GE-NE-0000-0002-9600-01R2a  
DRF 0000-0028-4024  
Revision 2  
Class I  
May 2004

**Pressure-Temperature Curves  
For  
Exelon  
Dresden Unit 3**

In accordance with 10 CFR 50.90, "Application for amendment of license or construction permit," Exelon Generation Company, LLC (EGC) requests a change to Facility Operating License Nos. DPR-29 and DPR-30, and to Technical Specifications (TS), Section 3.4.9, "Reactor Coolant System Pressure and Temperature (P/T) Limits," for Quad Cities Nuclear Power Station (QCNPS), Units 1 and 2. This amendment request revises the P/T limits curves for 54 effective full power years (EFPY), and resolves a non-conservative condition for TS Section 3.4.9, Figure 3.4.9-2, "Non-Nuclear Heatup/Cooldown Curve," for QCNPS. In accordance with NRC Administrative Letter 98-10, "Dispositioning of Technical Specifications That Are Insufficient to Assure Plant Safety," administrative controls have been put in place at QCNPS until the license amendment request is approved.

Figure 3.4.9-1 (Page 1 of 1)  
Non-Nuclear Inservice Leak and Hydrostatic Testing Curve  
(Valid to 54 EFPY)

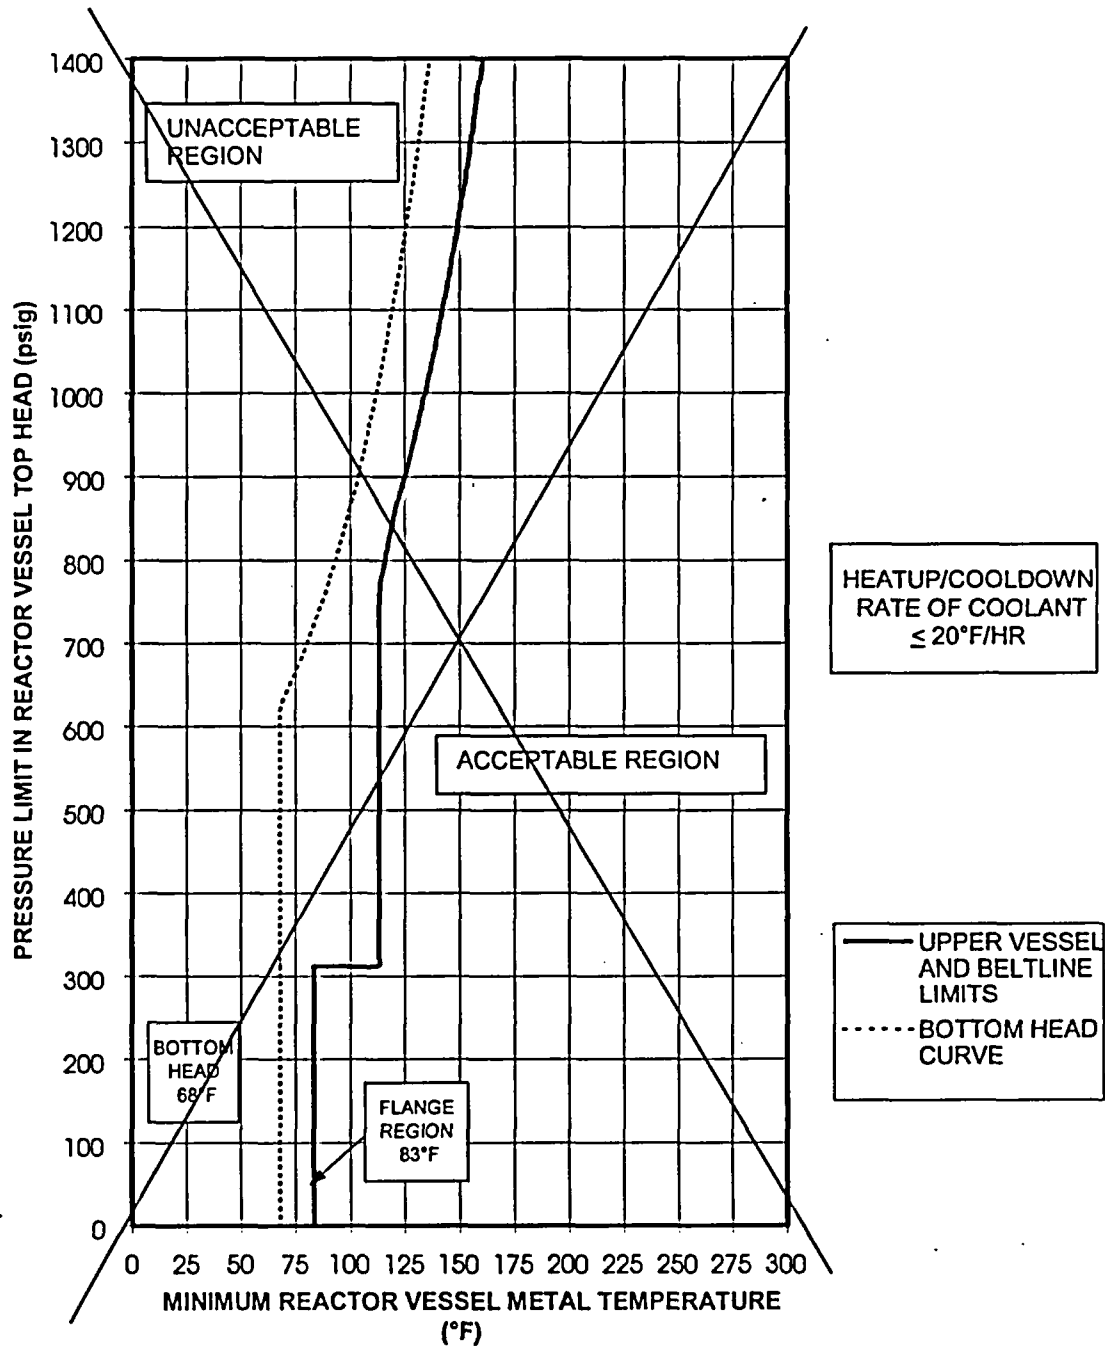
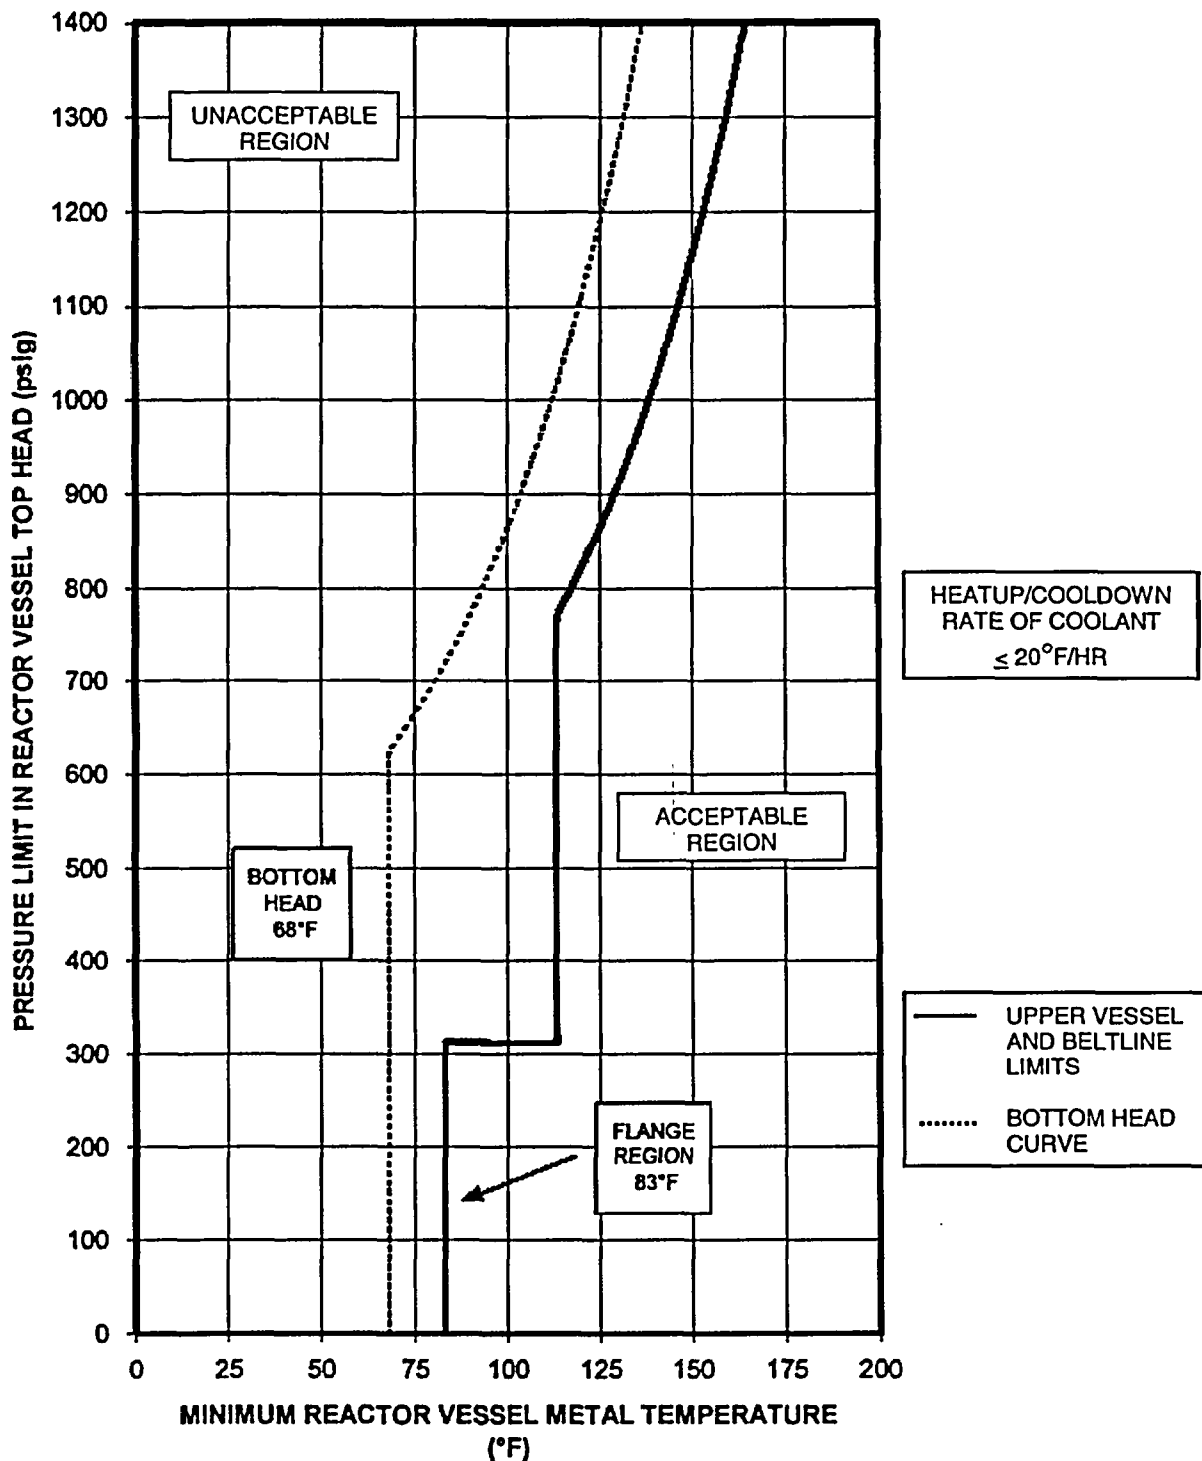
- Replace the current TS Figures 3.4.9-1, 3.4.9-2, and 3.4.9-3 with revised TS Figures 3.4.9-1 through 3.4.9-3. The revised P/T curves are applicable to 54 effective full power years (EFPY) as determined for a 40-year license with a 20 year renewed period.

TS Figure	TS Page	Title	GE Report Figure	GE Report Page
3.4.9-1	3.4.9-6	"Non-Nuclear Inservice Leak and Hydrostatic Testing Curve"	G-13, Curve A	G-16
3.4.9-2	3.4.9-7	"Non-Nuclear Heatup/Cooldown Curve"	G-14, Curve B	G-17
3.4.9-3	3.4.9-8	"Critical Operations Curve"	G-10, Curve C	G-13

54

Figure 3.4.9-2 (Page 1 of 1)  
Non-Nuclear Heatup/Cooldown Curve  
(Valid to 54 EFPY)

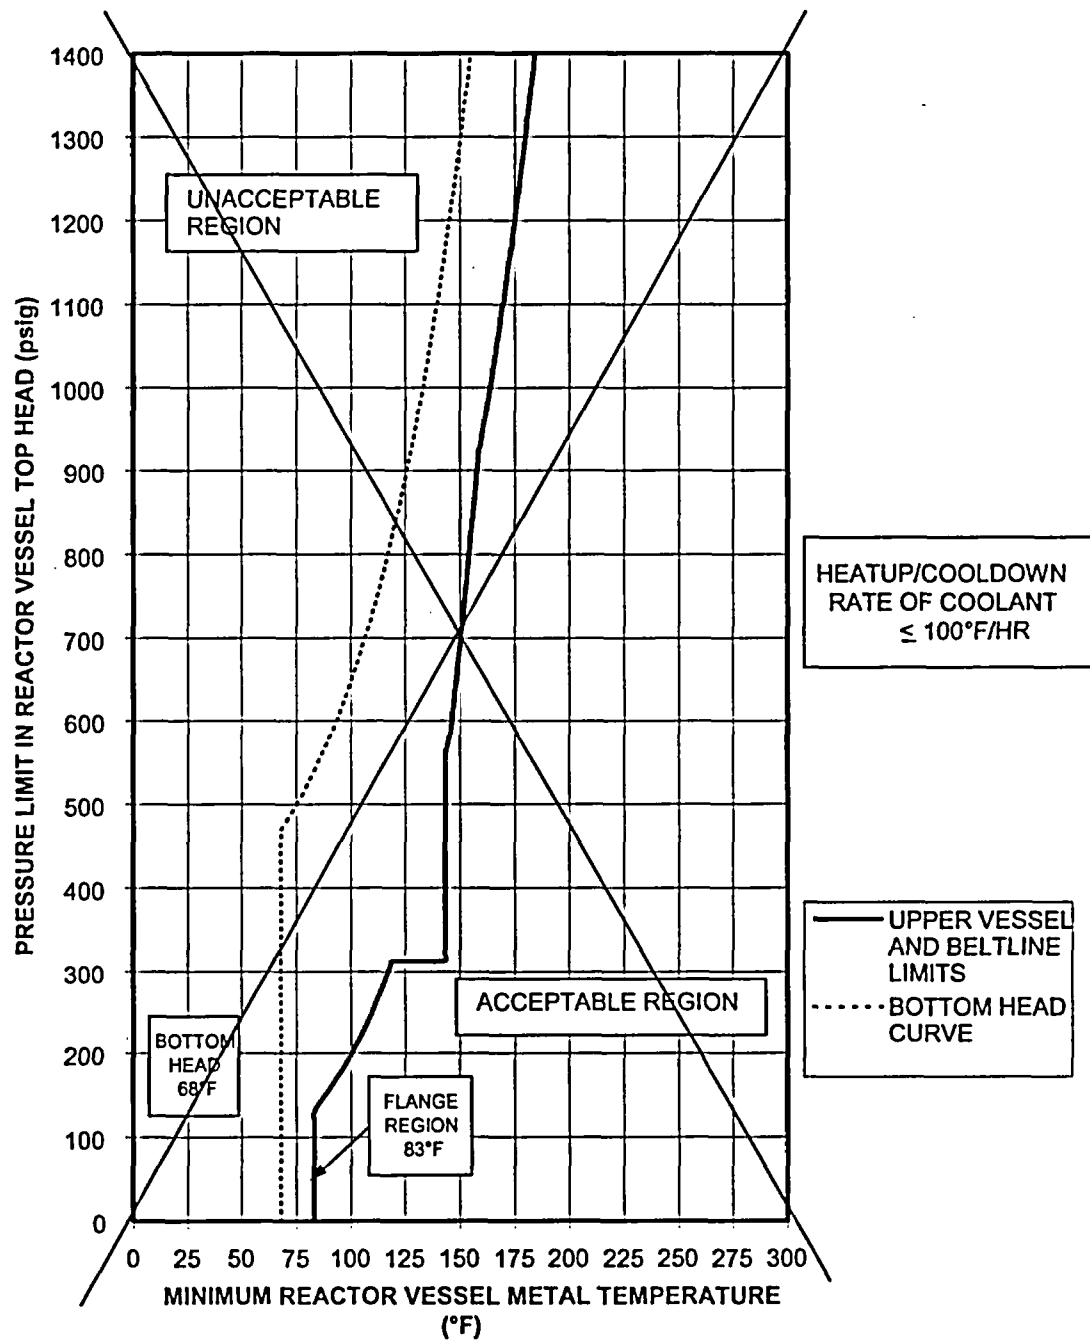
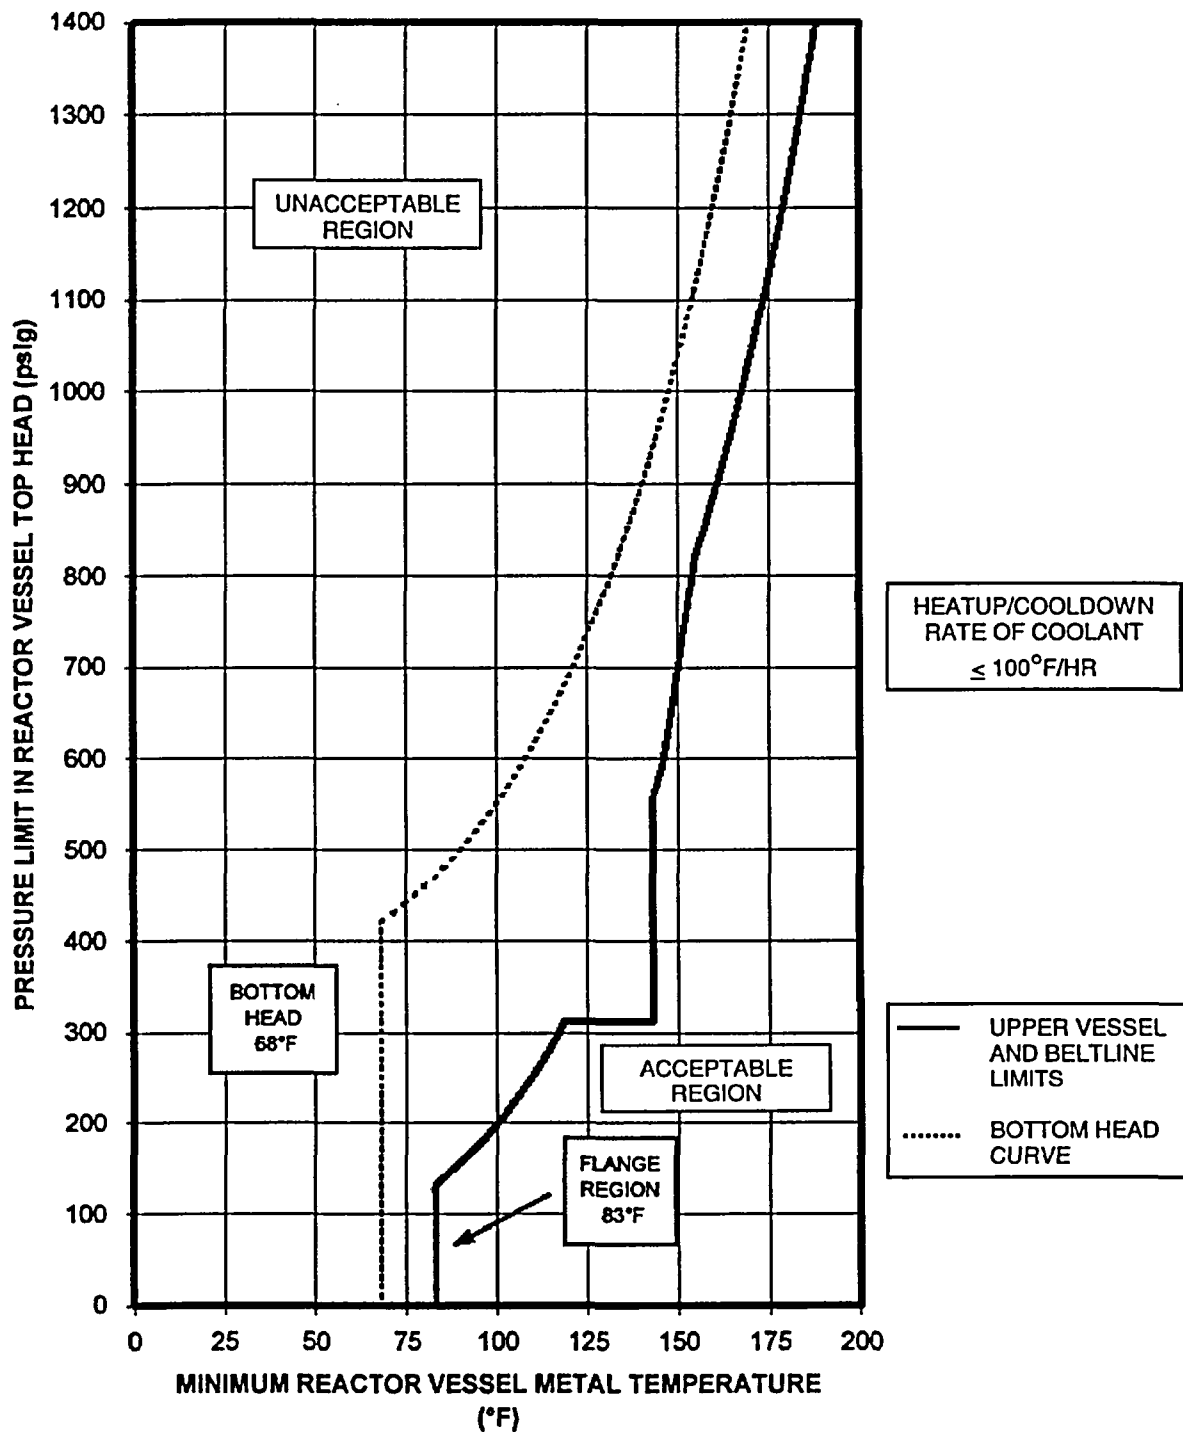
An evaluation was performed using plant specific inputs to scale the stresses for the limiting normal and upset thermal transients, which determined that the bottom head region of the non-nuclear heatup/cooldown curve was non-conservative for QCNPS. Specifically, the current P/T curve for the reactor pressure vessel bottom head region of Figure 3.4.9-2, "Non-nuclear Heatup/Cooldown Curve," was determined to be non-conservative by 14.6 degrees Fahrenheit (°F) for QCNPS Unit 1 and 11.6°F for Unit 2 during a bounding anticipated operational occurrence for the improper start of an idle recirculation pump, which is more severe than the normal upset condition (i.e., loss of feedwater transient). Since the P/T limits are established considering the safety factors of ASME Section XI, Appendix G, this non-conservatism in the region of the bottom head curve implies that a safety factor of two may not be maintained if the plant is conducting operations with the RPV bottom head pressure and temperature near the existing curve in TS Figure 3.4.9-2.

54
